To: Gary Wert
From: Jeff Walton, Associate Planner; 910-341-3260
CC: File;
Date: 8/15/2016
Re: Ogden Marketplace Planning Comments (Landscape revisions)

Landscape Plan:

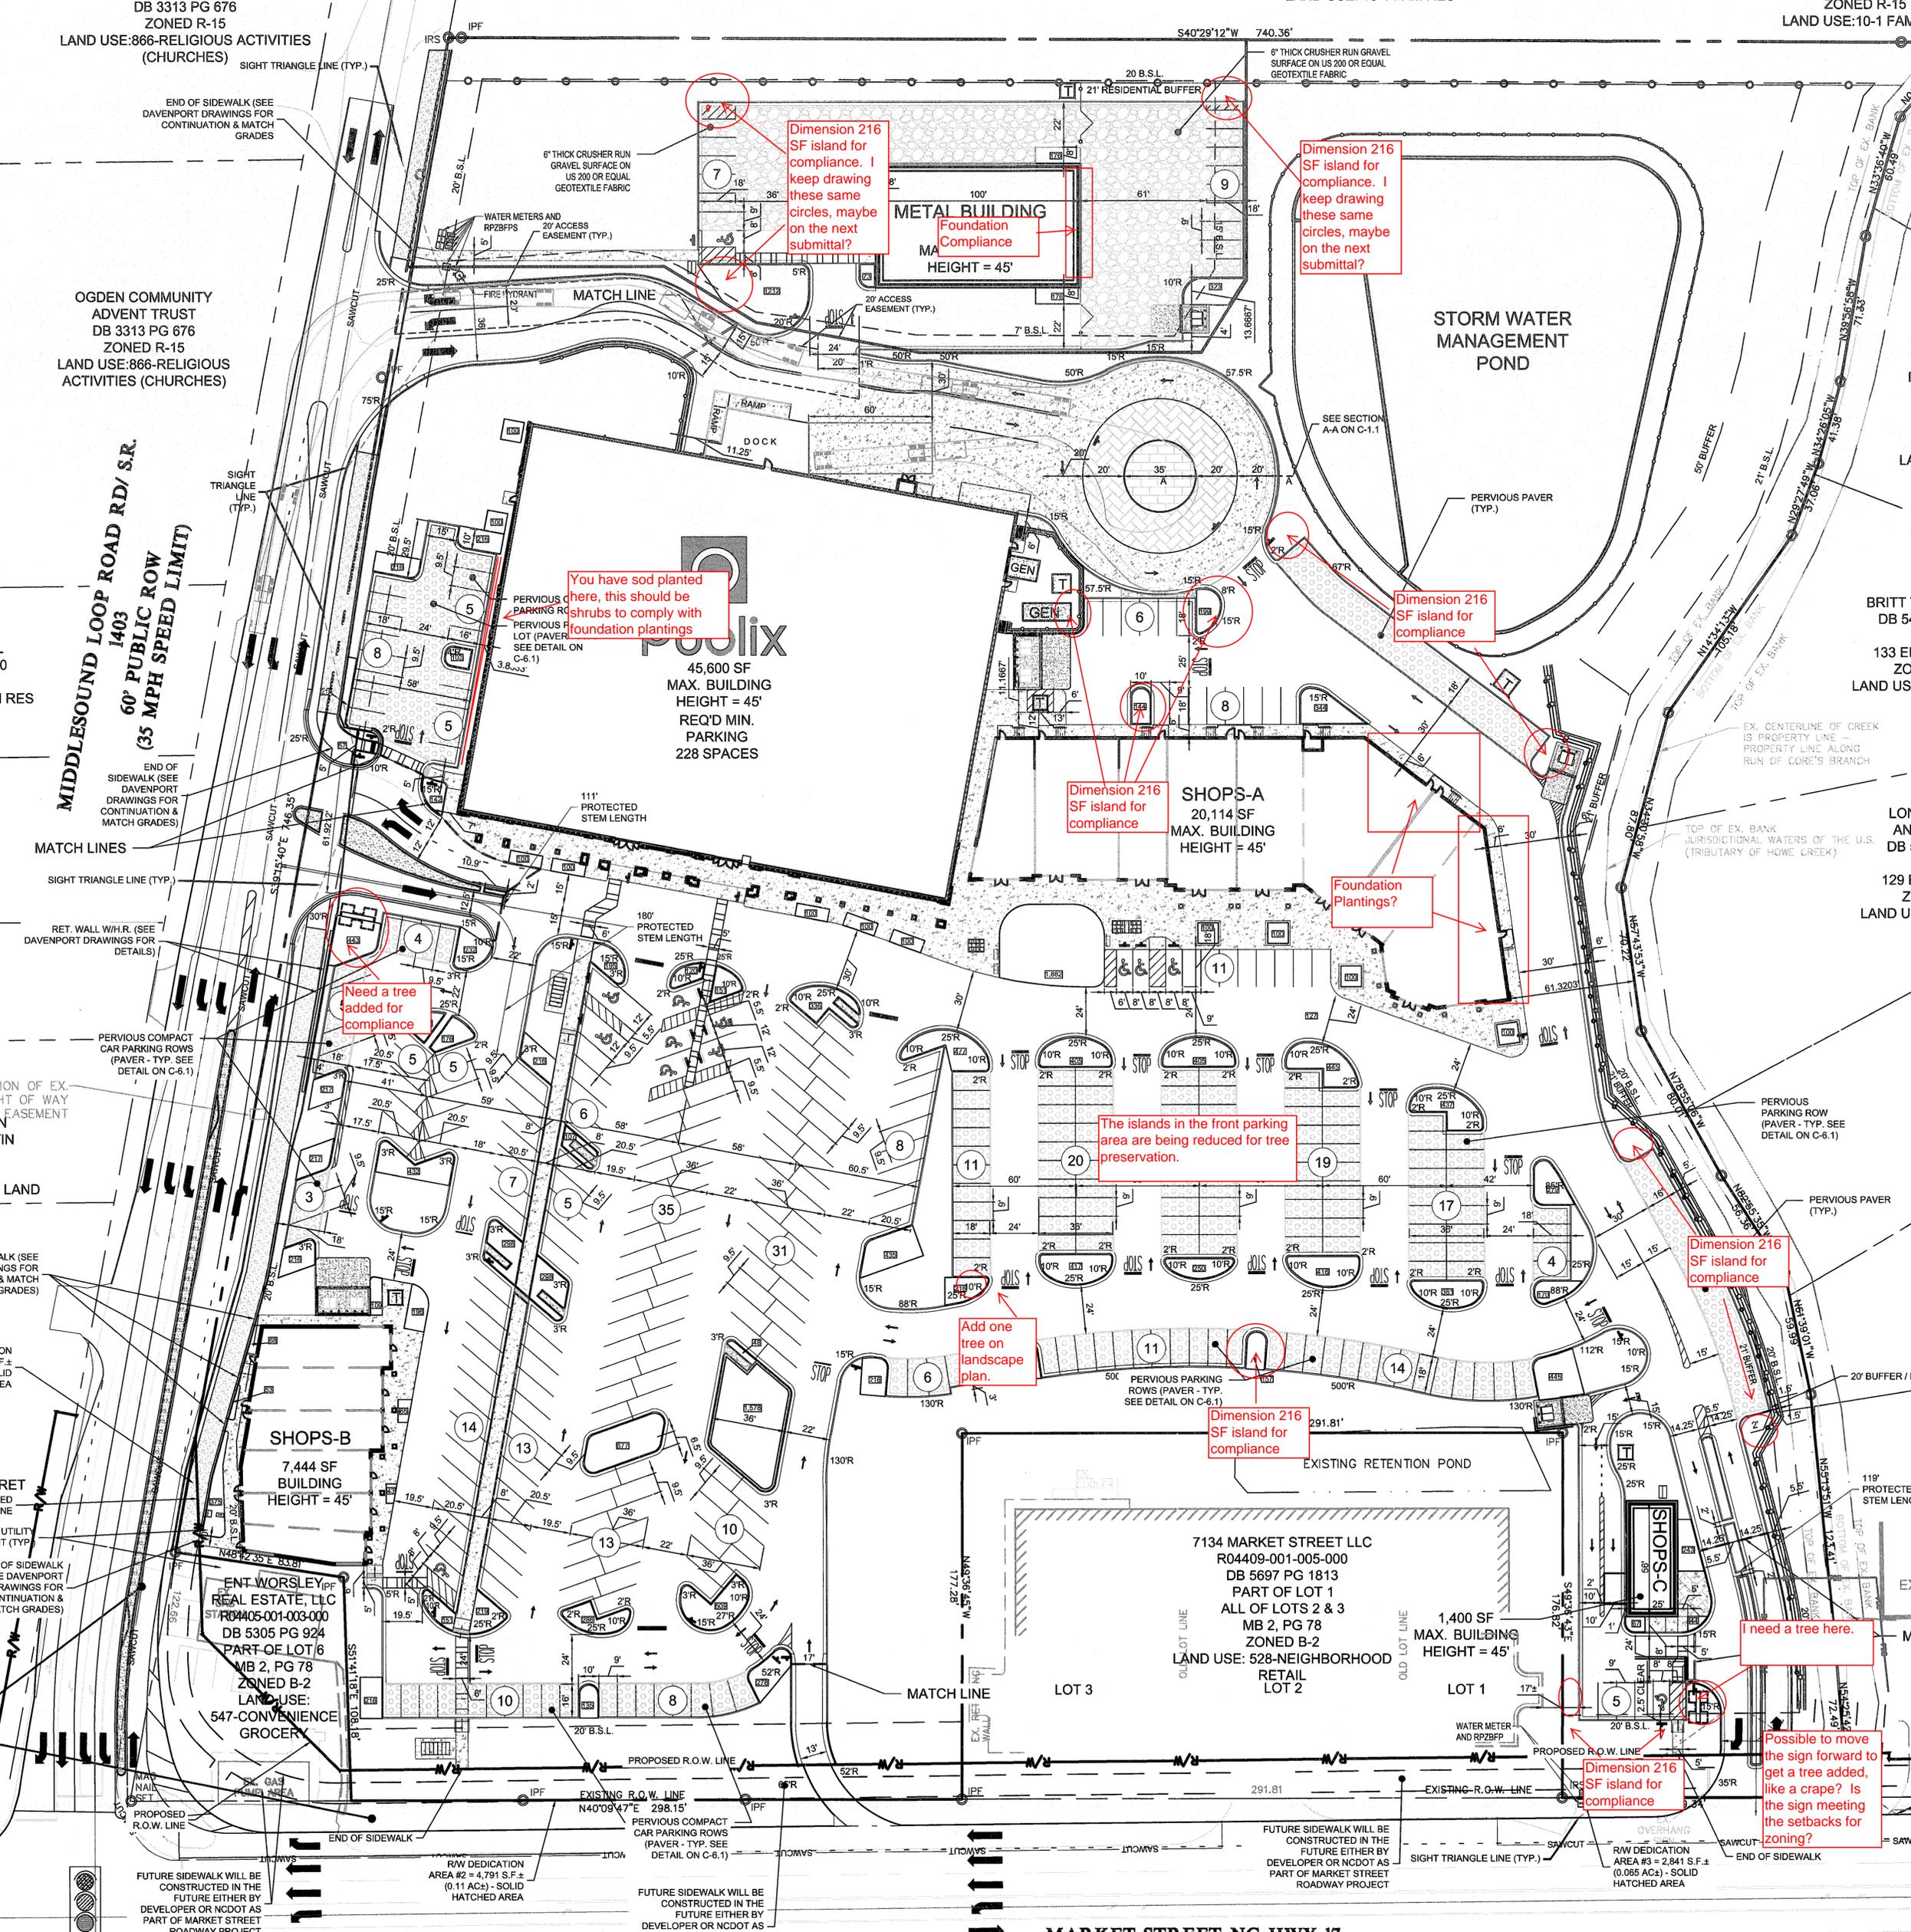
- The bufferyard to the south needs to be supplement with shrubs along with the proposed trees.
- I added notes to the redline concerning landscape islands and trees.

Dimension 216
SF island for
compliance. I
keep drawing
these same
circles, maybe
on the next
submittal?

Dimension 216
SF island for
compliance. I
keep drawing
these same
circles, maybe
on the next
submittal?

You have sod planted
here, this should be
shrubs to comply with
foundation plantings

Dimension 216
SF island for
compliance

Dimension 216
SF island for
compliance

Foundation
Plantings?

Need a tree
added for
compliance

Dimension 216
SF island for
compliance

Add one
tree on
landscape
plan.

Dimension 216
SF island for
compliance

I need a tree here.

Dimension 216
SF island for
compliance

Possible to move
the sign forward to
get a tree added,
like a crane? Is
the sign meeting
the setbacks for
zoning?

The islands in the front parking
area are being reduced for tree
preservation.

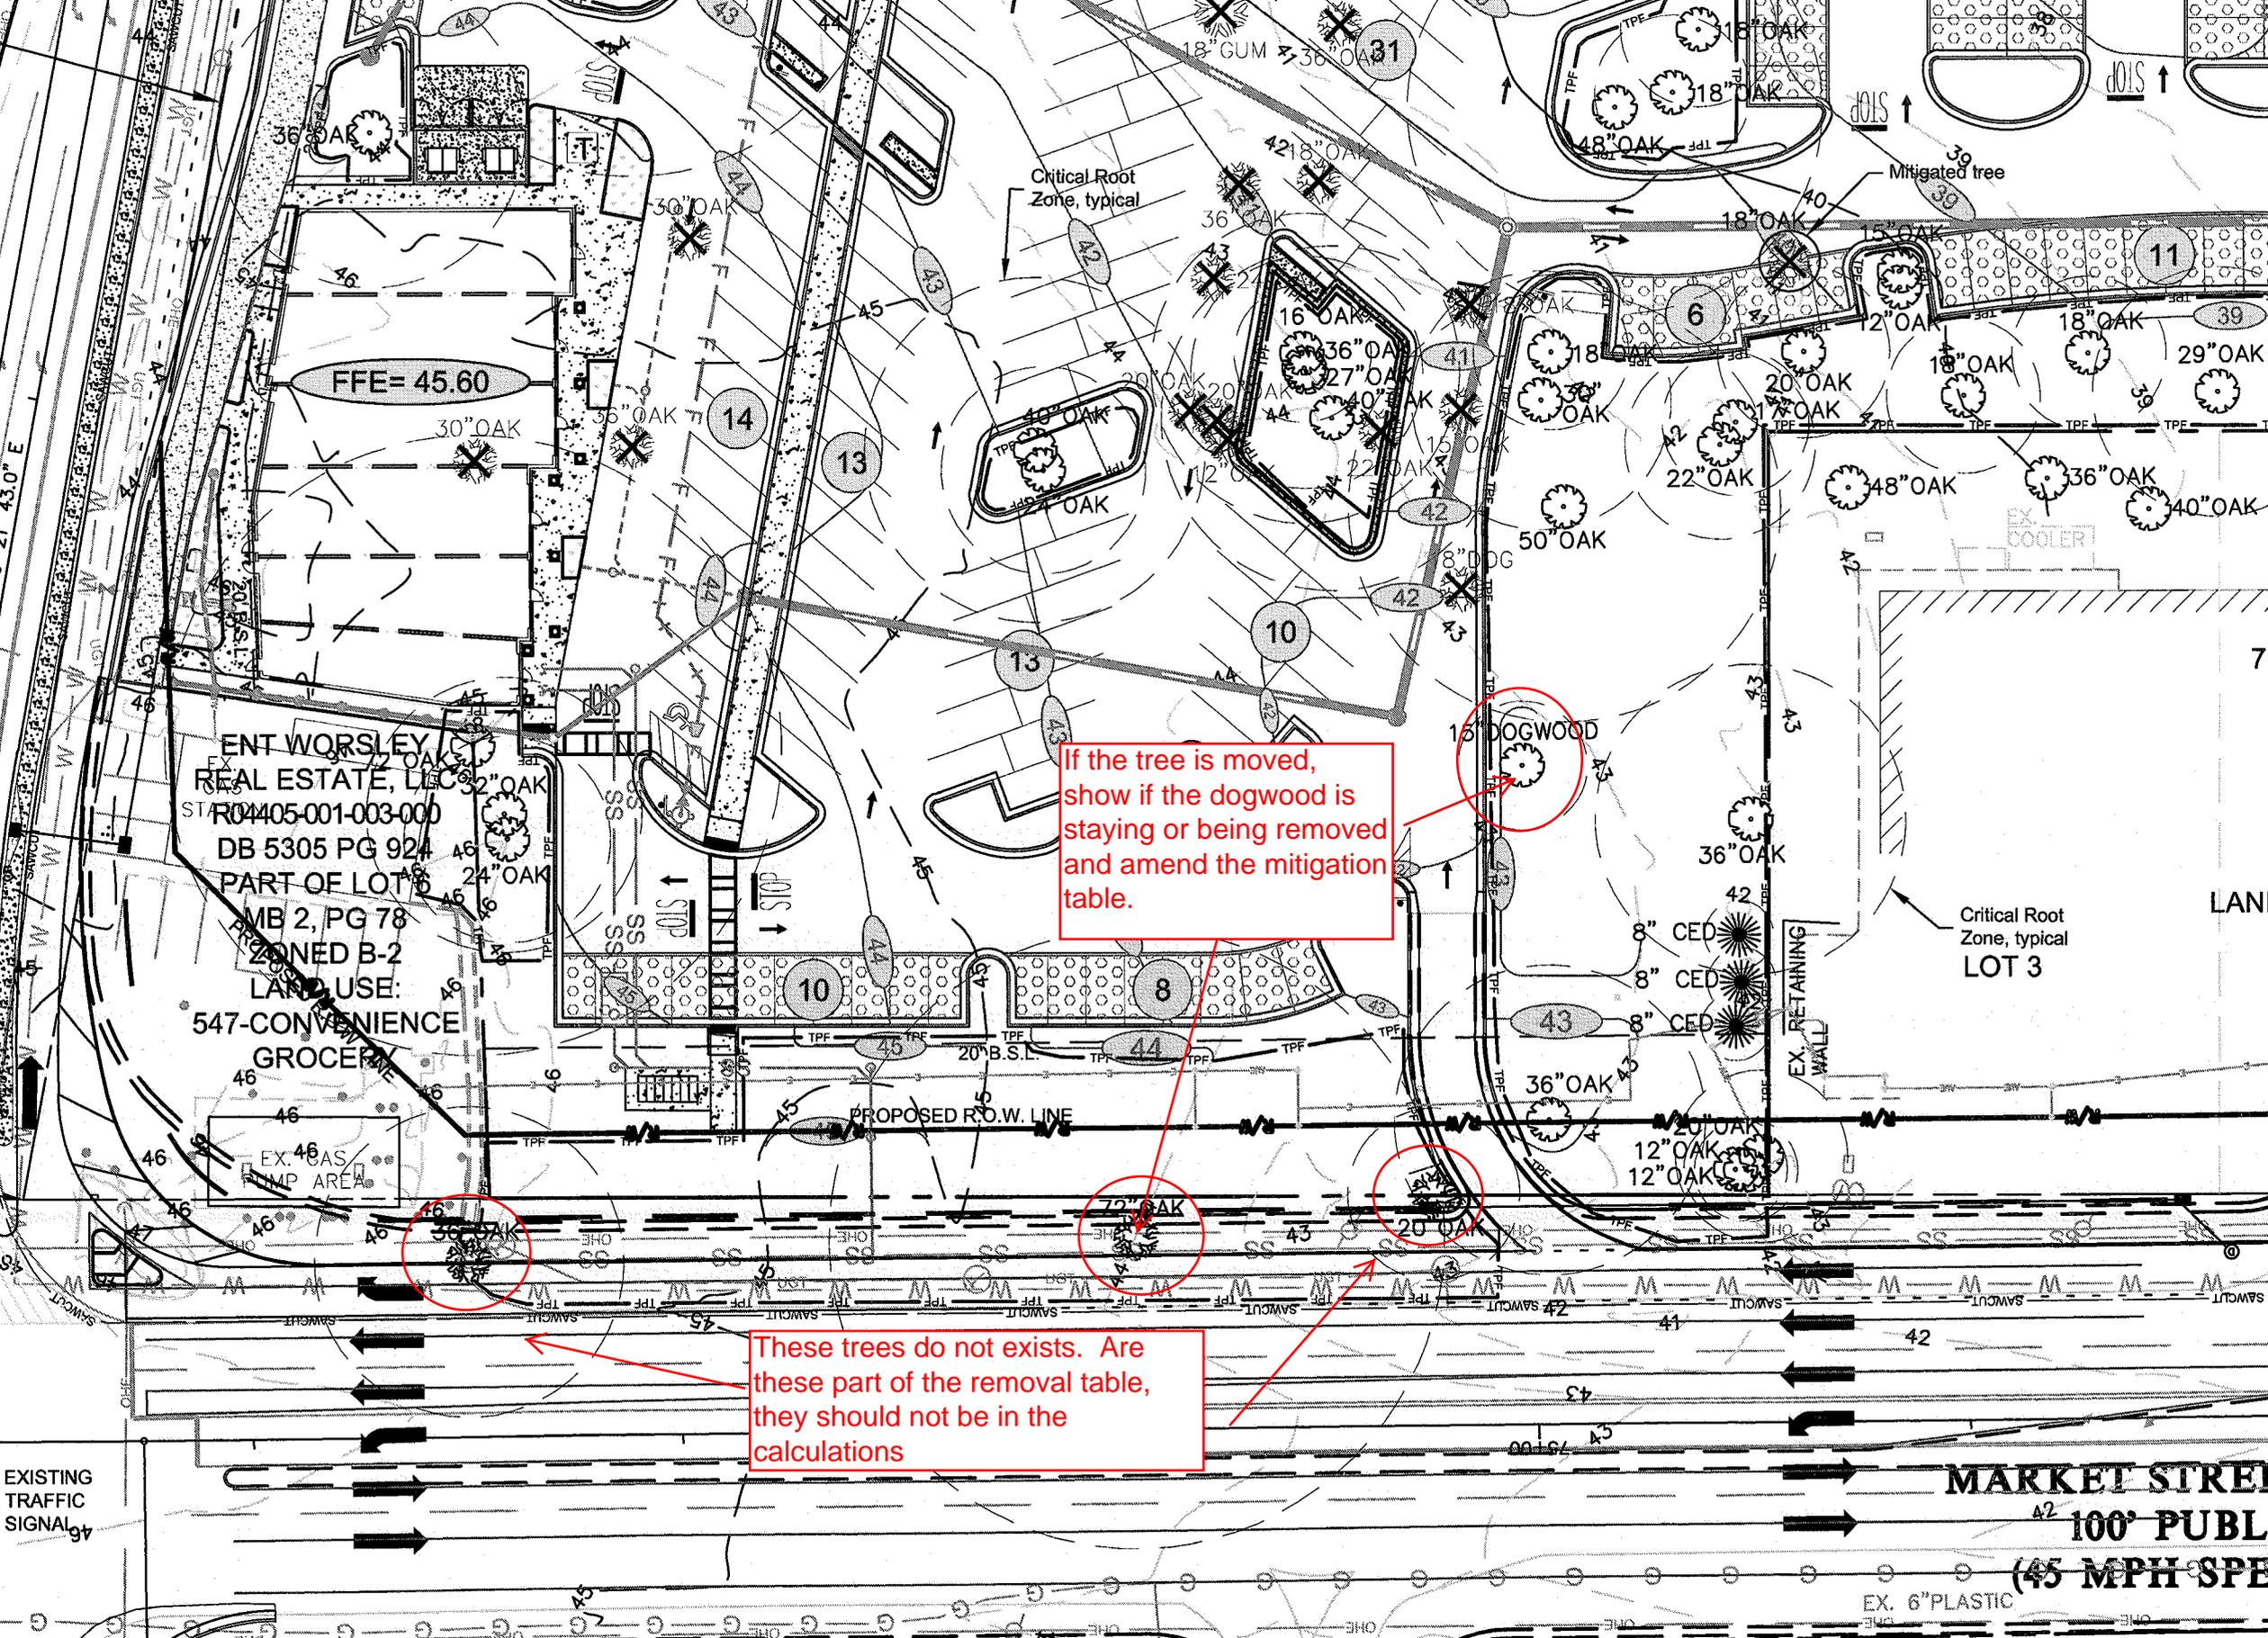
If the tree is moved, show if the dogwood is staying or being removed and amend the mitigation table.

These trees do not exist. Are these part of the removal table, they should not be in the calculations
